Intel® Desktop Board D845BG Specification Update

Release Date: October 2002

Order Number: A83340-006

Figure 4. Block Diagram with Optional USB 2.0 Support

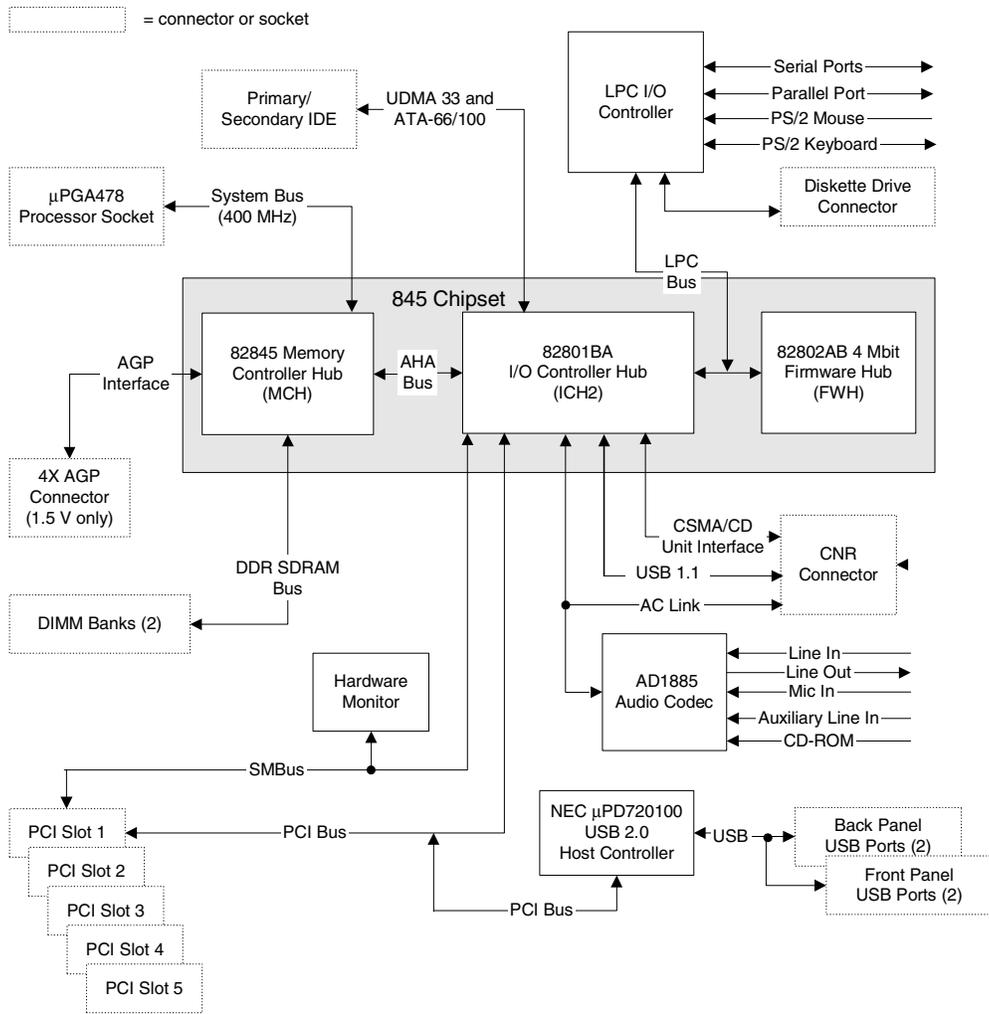
2. **Change to Section 1.2.4, Block Diagram, Figure 4**

Section 1.2.4, Block Diagram, Figure 4 will correct CNR USB routing:

Figure 7. USB 2.0 Port Configuration (Optional)

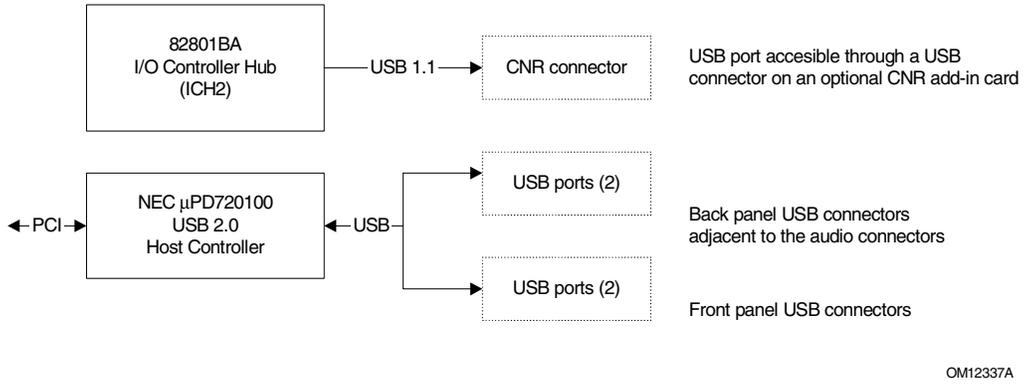
3. **Change to Description of Section 1.8.2.2, USB 2.0 Support (Optional)**

Section 1.8.2.2, USB 2.0 Support (Optional), will change in its entirety as follows:

The D845BG board supports USB 2.0 using the NEC μ PD720100 USB 2.0 host controller, which is a manufacturing option. The port routing is implemented as shown in Figure 7. The NEC μ PD720100 controller is connected through the PCI bus and provides support for up to four USB ports:

USB Routing to the CNR connector only supports USB 1.1 CNR devices

Figure 9. ICH2 and CNR Signal Interface

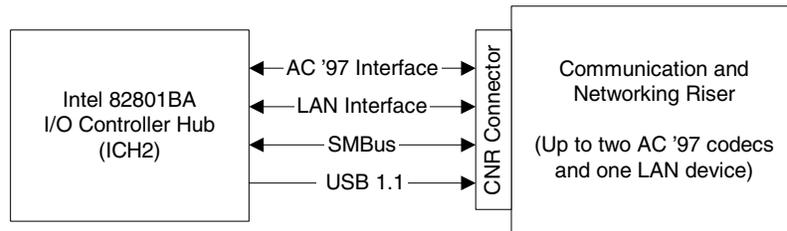
4. Change to Description of Section 1.12, CNR (Optional)

The CNR connector provides an interface that supports the audio, modem, USB, and LAN interfaces of the Intel® 845 chipset. Figure 9 shows the signal interface between the riser and the ICH2.

- AC '97 interface: supports audio and/or modem functions on the CNR card.
- LAN interfaces: an eight-pin interface for use with Platform LAN Connection (PLC) based devices.
- SMBus interface: provides Plug-and-Play functionality for the CNR card.
- USB interface: provides a USB 1.1 interface for the CNR card.
